**Re: Item #8a: Coastal Resilience Master Plan and Programmatic Environmental Impact Report - *Discussion of draft plan and PEIR and adoption of recommendation(s)***

**[EXTERNAL] Draft Coastal Resilience Master Plan**

## **Mission Beach**

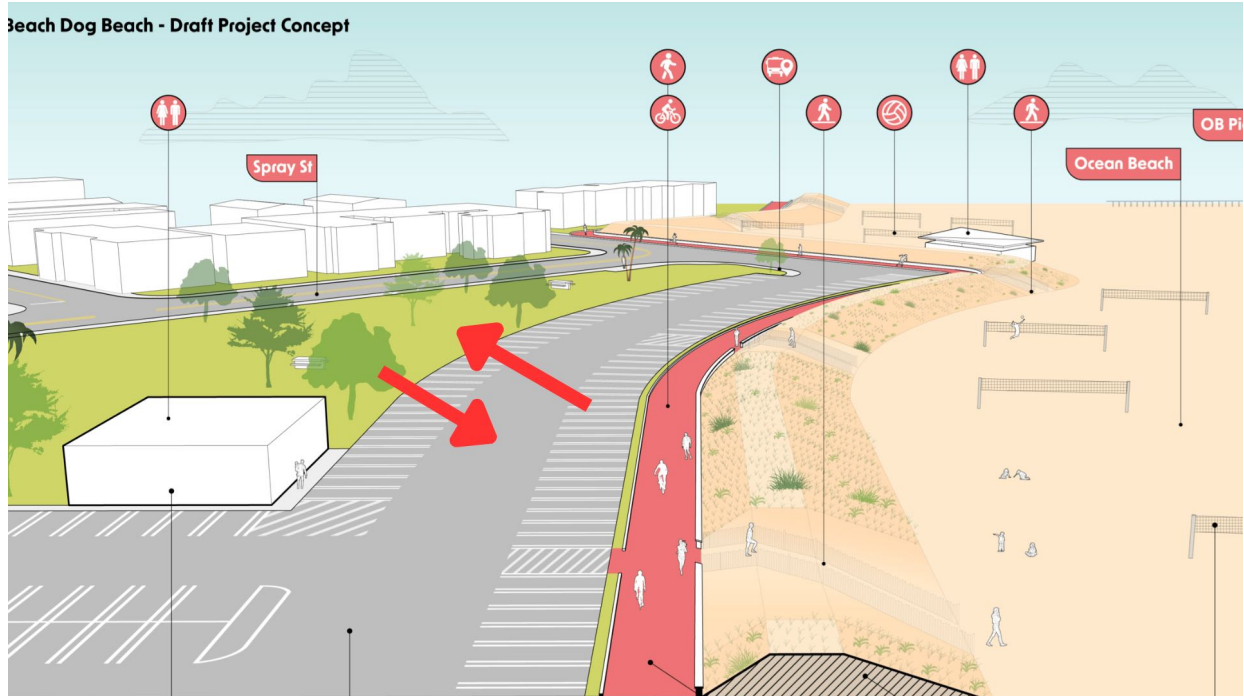
For Mission Beach, we urge adoption of *Project Concept D-2: Perched Beach* because it incorporates additional beach recreation space. Beach recreation space is a coastal-dependent resource, therefore it must be given priority over grass parkland on the coast. Furthermore, there is ample grass space elsewhere along Mission Beach and Bay.

Echoing our comments for the previous project designs, the City should take every opportunity to move the beach landward where it's possible to do so. Landward migration of the beach, wherever feasible, is the most effective, durable, and cost-effective nature-based solution to preserve this critical recreational space.

Beach Dog Beach - Draft Project Concept

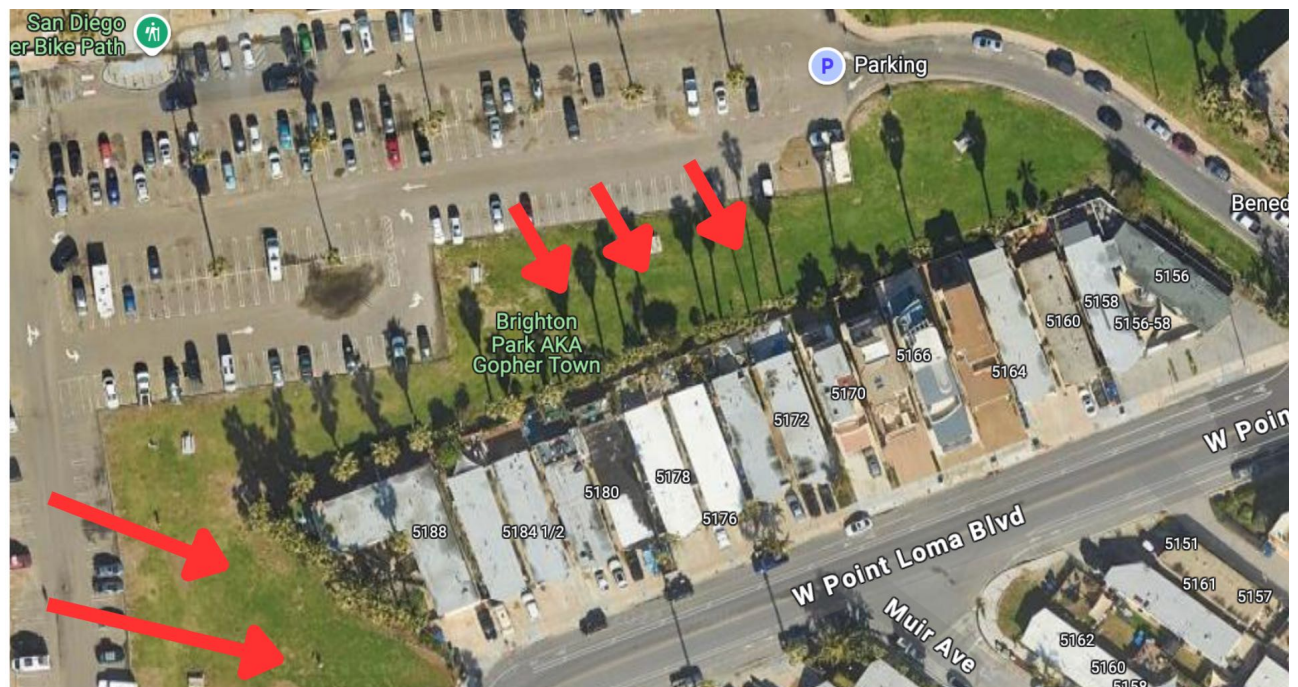
Thanks to a wider beach, Ocean Beach is less immediately threatened than Tourmaline or even La Jolla Shores. That said, we encourage a more detailed look at ways to reorient underutilized space in the Dog Beach parking lot to increase overall beach resilience. Brighton Park, which runs the entire length from Brighton to Voltaire, is underutilized because it's adjacent to the parking lot and not the beach. (similar to Tourmaline's green space).

A more resilient project for Dog Beach could borrow the same *Reconfigured Park* concept being considered at La Jolla Shores, by moving the park seaward and replacing it with the lost parking spaces. Doing so would create an attractive beachfront park that is unobstructed by parked cars. A floodable park would also add an additional layer of resilience, by protecting the infrastructure behind it from coastal storm surge.

*Swapping the park with the parking lot would increase resilience to flooding, while replacing an underutilized park with an attractive beachfront park*

*Brighton Park is underutilized due to its bad location. Such space would be more beneficial if beach-adjacent.*
